QA: N/A
Project No. WM-00011

TRANSMITTAL OF THE OFFICE OF CIVILIAN RADIOACTIVE WASTE
MANAGEMENT (OCRWM) QUALITY ASSURANCE REQUIREMENTS AND
DESCRIPTION (QARD), REVISION 15

The U.S. Department of Energy's (DOE) OCRWM is requesting U.S. Nuclear Regulatory Commission (NRC) review and acceptance of Revision 15 of the QARD. Revision 15 is included as Enclosure 1.

FIGURE 1-1

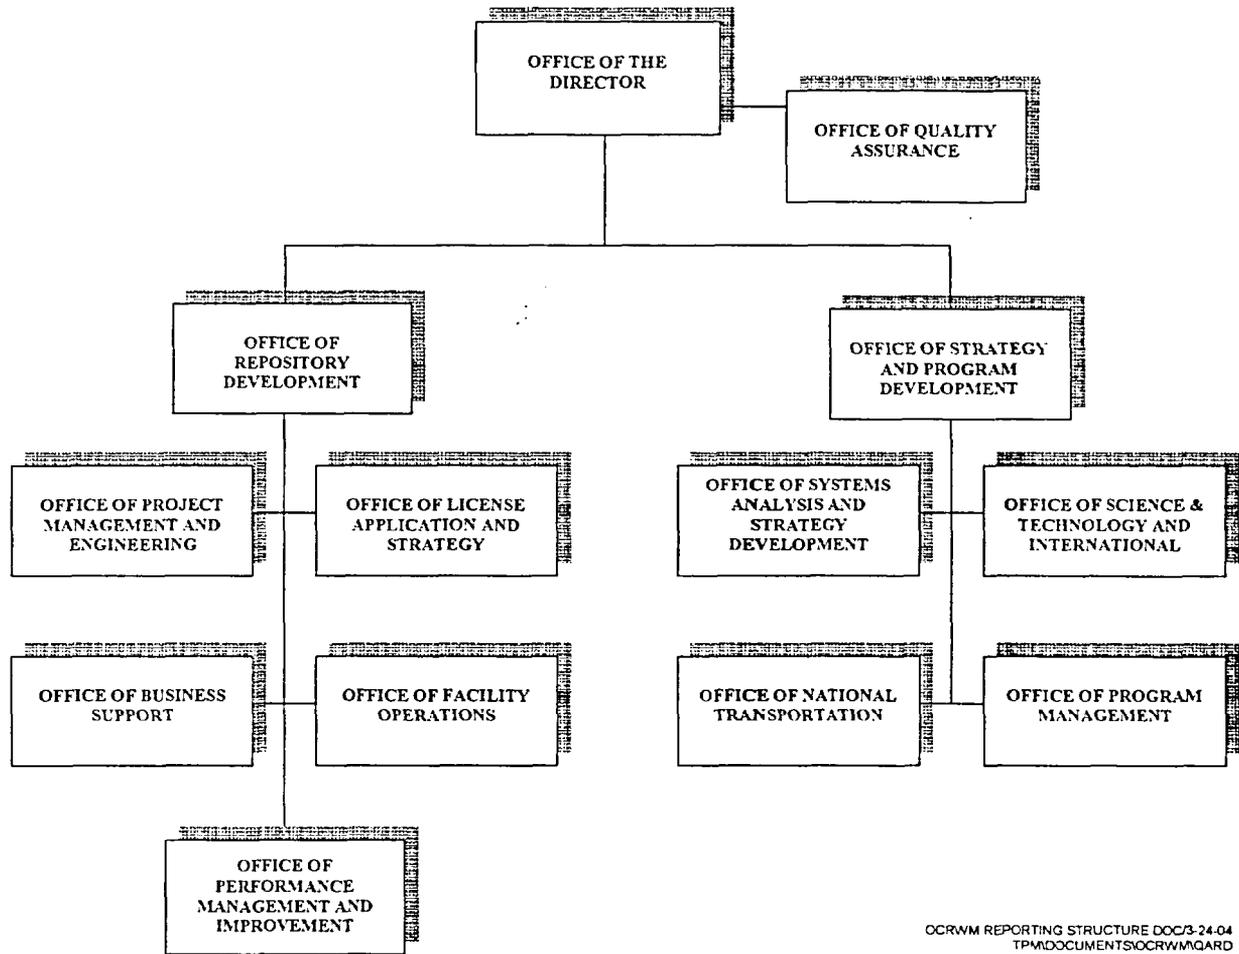
- Revised Subsection 1.3.2 to address ORD reorganization.
- Revised Figure 1-1 to reflect ORD reorganization.
- Revised the Glossary definitions for Performance Assessment and Performance Confirmation to be consistent with 10 CFR 63.2. These terms are used in the Office of License Application and Strategy responsibilities.
